## **AMENDMENT C278GCEE: MARSHALL PRECINCT STRUCTURE PLAN - CONSIDERATION OF SUBMISSIONS**

**To:** Peter Smith - Coordinator, Strategic Implementation  
**From:** Peter Schembri - Senior Strategic Planner  
**Subject:** Resolution to consider submissions under delegation  
**File number:** Amendment C278ggee

1. To consider submissions to Planning Scheme Amendment C278ggee and recommend all the submissions be referred to an Independent Planning Panel.

Source: extract of Marshall PSP Plan 6 (page 29) showing #Property Identification Number

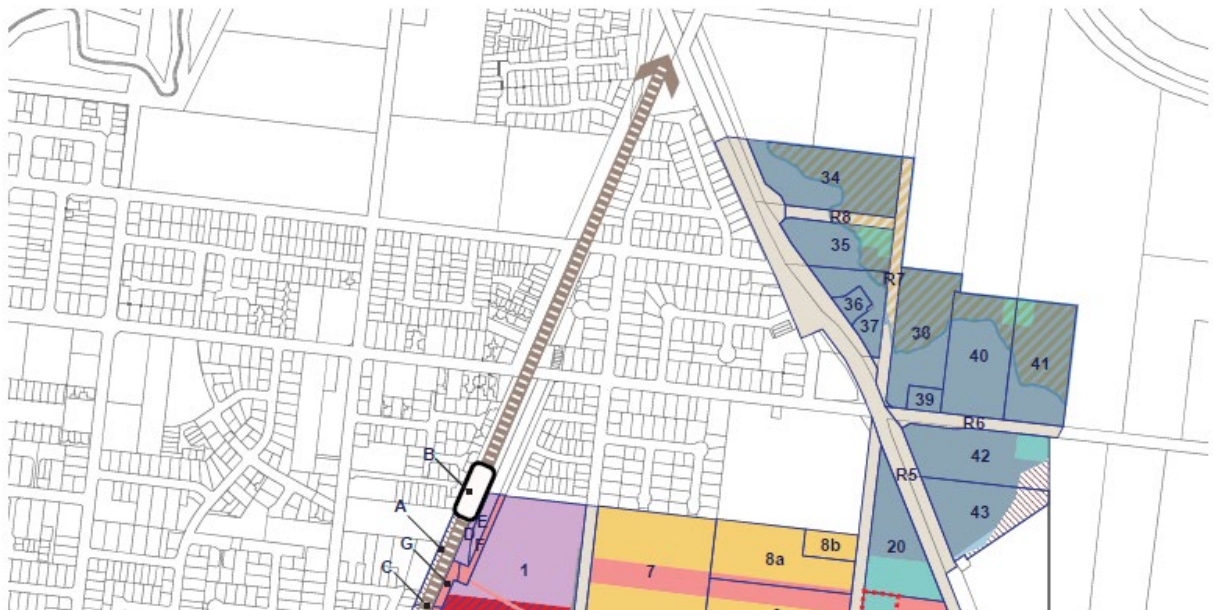
25. Mesh Planning (12) for an Armstrong Creek NEIP landowner (Re-Grow Geelong) requests the commercial/ bulky goods area along Barwon Heads Road be re-designated for medium and high density housing. The exhibited applied zone for this land area is Commercial 2 Zone (C2Z). Mesh say the C2Z is unplanned, departs from the *Armstrong*

27. The Ratio submission (15) supports the commercial/ bulky goods designation and applied C2Z. The submission requests strengthening of the Marshall PSP by referring to employment uses in the Vision and Objectives. There is objection to the UGZ7 supermarket prohibition and specific provisions requiring preparation of a masterplan for the commercial/ bulky goods sub-precincts.

40. Council supports the following Mesh submission requests:
  - 40.1 Change the PSP designation of land east of Barwon Heads Road and south of Tannery Road (Properties #42 and 43); and land east of Horseshoe Bend Road and north of Tannery Road (Properties #38, 39, 40 and 41) to 'Conventional

- 40.2 Change the PSP designation of land west of Barwon Heads Road (Property #20) to 'Medium/High Density Residential'. The UGZ7 applied zone will be Residential Growth Zone Schedule 1.
41. The balance of the designated commercial/ bulky goods area located between Barwon Heads Road and Horseshoe Bend Road, north of the Barwon Heads Road/ Tannery Road/ Marshalltown Road intersection (Properties #34, 35, 36 and 37) is to remain as exhibited. Council disagrees with the Mesh submission to re-designate this area for residential use.
42. In summary, Council proposes the following:
- 42.1 'Conventional Residential' designation: Properties #38, #39, #40, #41, #42 and #43
- 42.2 'Medium/High Density Residential' designation: Property #20
- 42.3 'Commercial/Bulky Goods' designation: Properties #34, #35, #36 #37 (no change)

**Attachment 3 - Post-exhibition Marshall PSP Future Urban Structure (Plan 5)**

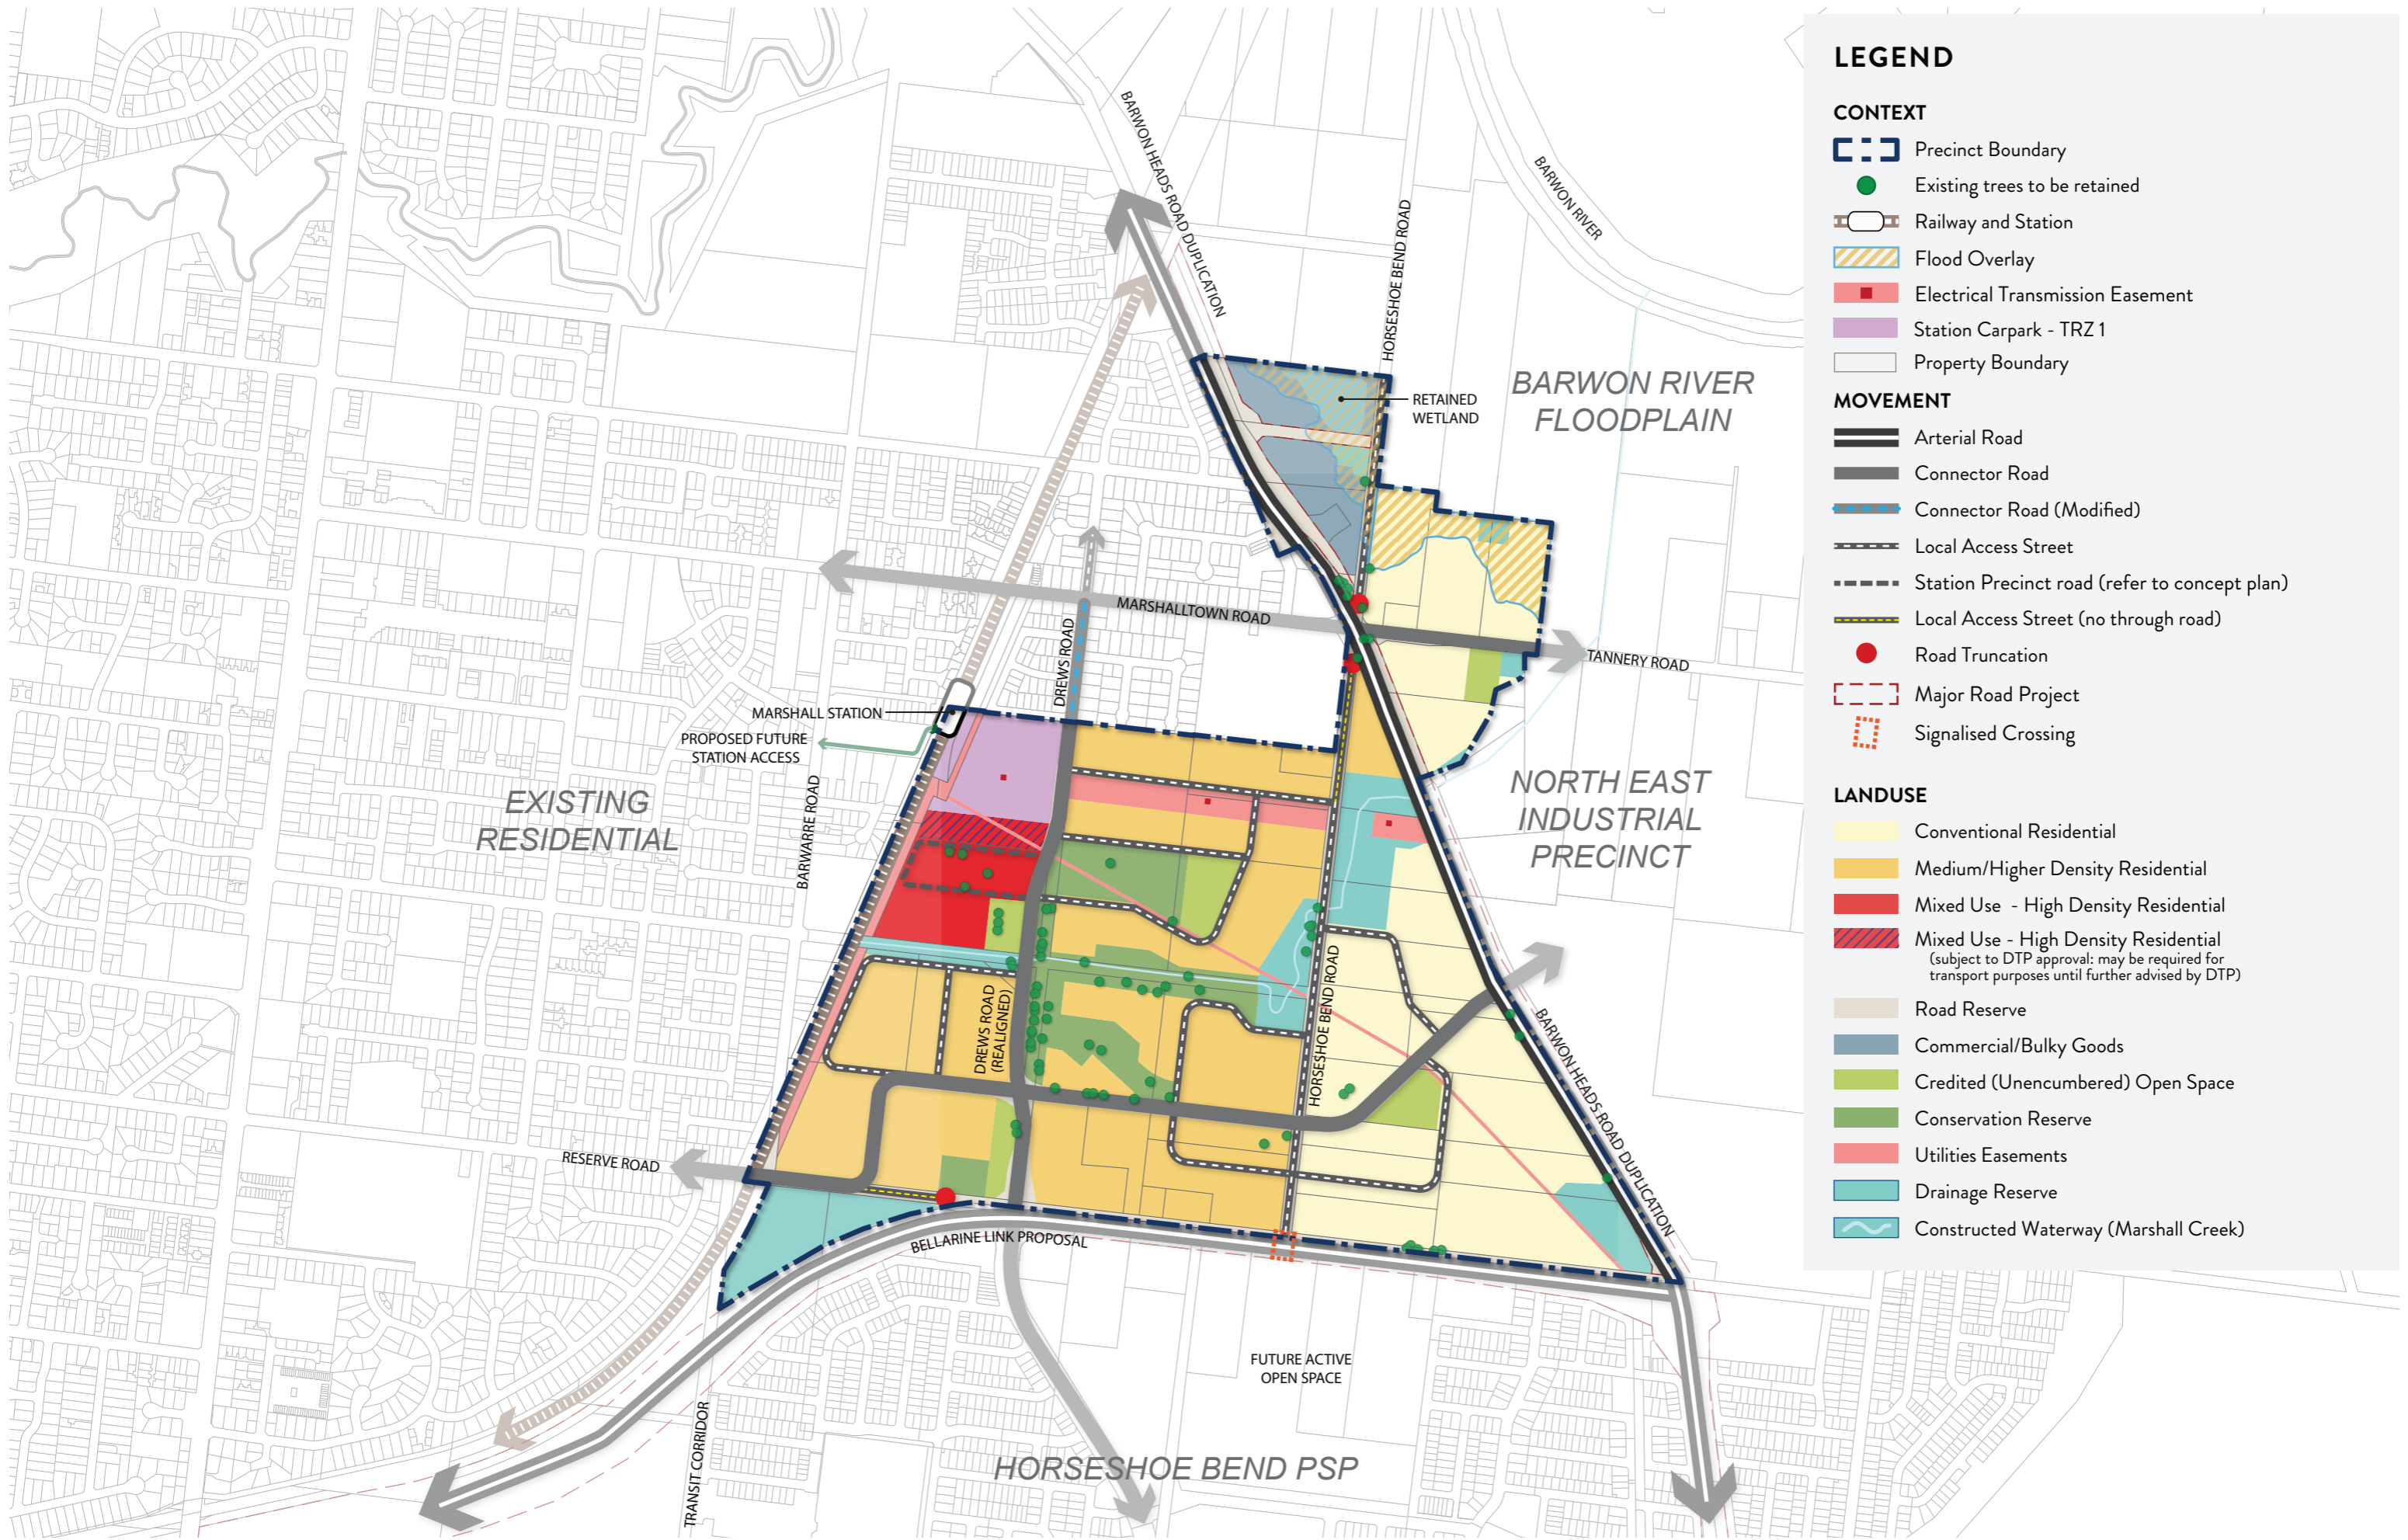
13. The most critical change is to change most of the Marshall PSP 'Commercial/Bulky Goods' land-use designation to a combination of 'Medium/High Density Residential' and 'Conventional Residential'. A revised Marshall PSP *Future Urban Structure* (Plan 5 map) inclusive of these changes is presented in **Attachment 3**. Directly affected landowners will have an opportunity to submit on the proposed change at the panel hearing, should the recommendations of this report be approved.

122. Several submissions raised concerns with the exhibited Marshall PSP without providing specific requested changes to the document. The proposed re-designation of part of the 'Commercial/ Bulky Goods' area to a residential designation will require substantial changes to the document, including to most of the plans in Section 3.0 *Implementation*. The overall master plan for the PSP – Plan 5 *Future Urban Structure* – has been revised and is shown in **Attachment 3**.

59. Council's proposed re-designation for residential use will necessitate numerous changes to the exhibited PSP and DCP. No changes are required to the exhibited planning scheme maps but changes will be required to UGZ7. A revised Marshall PSP *Future Urban Structure* (Plan 5) is shown in **Attachment 3**, noting the plan is subject to review and refinement as part of the panel hearing process.
